Subject: Request for Information to be Included in Program to Determine
the Capability of Millstone 3 to Withstand Seismic Excitation
Above the Design SSE

OUTLINE OF PROGRAM TO DETERMINE THE CAPABILITY OF MILLSTONE 3

Comments on Northeast Utilities Program
to Determine the Capability of the Millstone-3
Nuclear Power Plant to Withstand Seismic
Excitation above the Design SSE

REVIEW OF THE REVISED
MILLSTONE UNIT 3 PROBABILISTIC SAFETY STUDY
SEISMIC FRAGILITY

FIGURE 2-1. MILLSTONE RESPONSE SPECTRA FOR 10% DAMPING

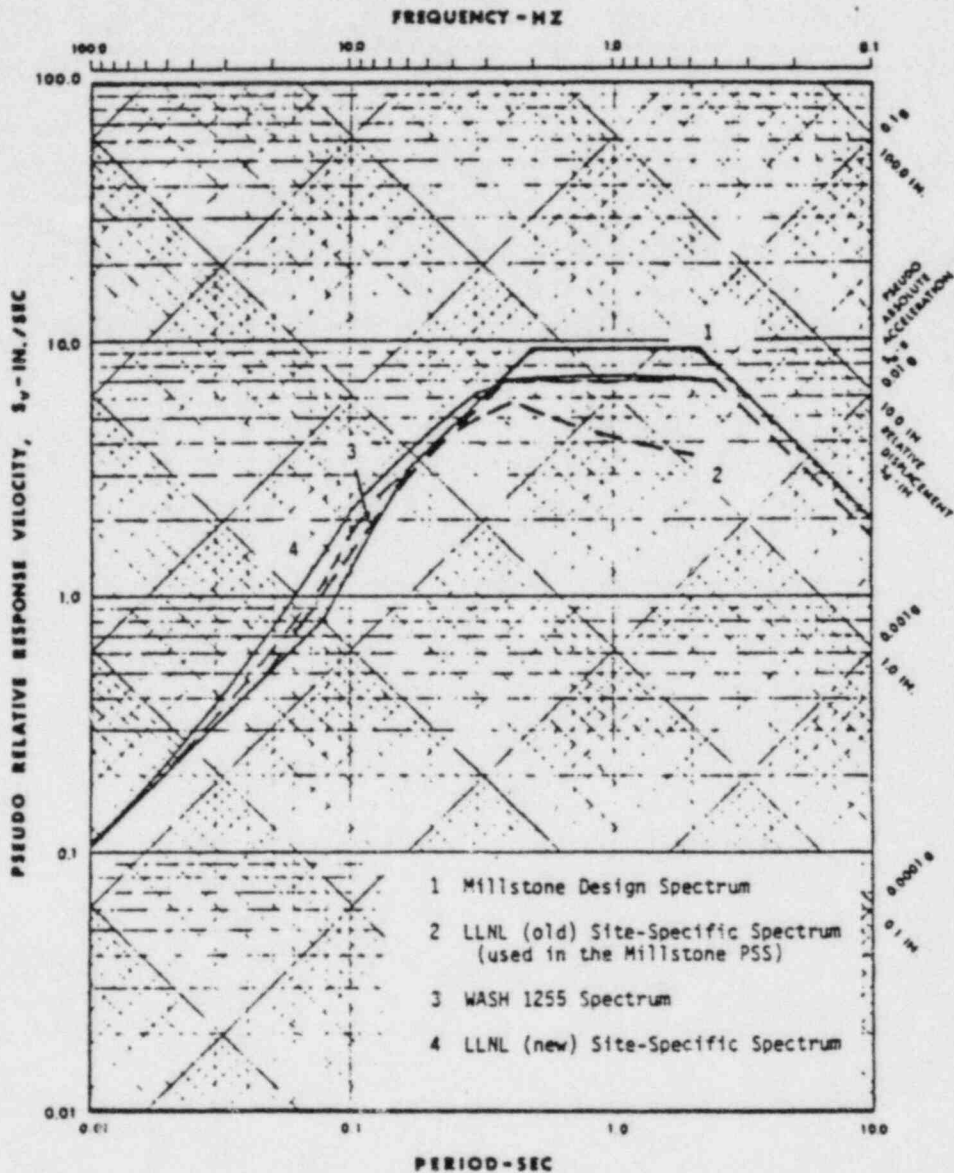
The response spectrum shape for earthquake magnitudes in the range 5.3 to 6.3 developed in Reference 11 for rock sites was used. Figure 2-1 shows this spectra with the Millstone design spectra for 10 percent damping. The procedure described in Reference 11 to convert the 5 percent damped spectrum to 10 percent damping was used. Each spectrum in the figure is scaled to 0.17g, the SSE level. Also shown in the figure is the WASH 1255 broad-band response spectrum.

In addition to these spectra, LLNL (Ref. 13) has conducted a new seismic hazard analysis for the Millstone site. In Figure 2-1, the 1000 year return period spectral shape scaled to 0.17g is shown.

Based on the comparison in Figure 2-1 we find that the magnitude-dependent spectra are generally higher than the design spectra for frequencies greater than 5 Hz. Among these, the most recent spectra developed by LLNL has the highest spectral level. At frequencies less than 5 Hz, the design spectrum exceeds the site-specific spectrum, with the greatest variations occurring at frequencies less than 2 Hz.

In comparison to the WASH 1255 broad-band spectra, the LLNL site-specific spectra both have higher spectral levels at frequencies beyond 5 Hz. In the 2-5 Hz region, the WASH 1255 is higher.

4. The NRC should determine if the site-specific spectrum used in the fragility analysis is appropriate. See Table 2-1 and Figure 2-1 for a comparison of different response spectra.
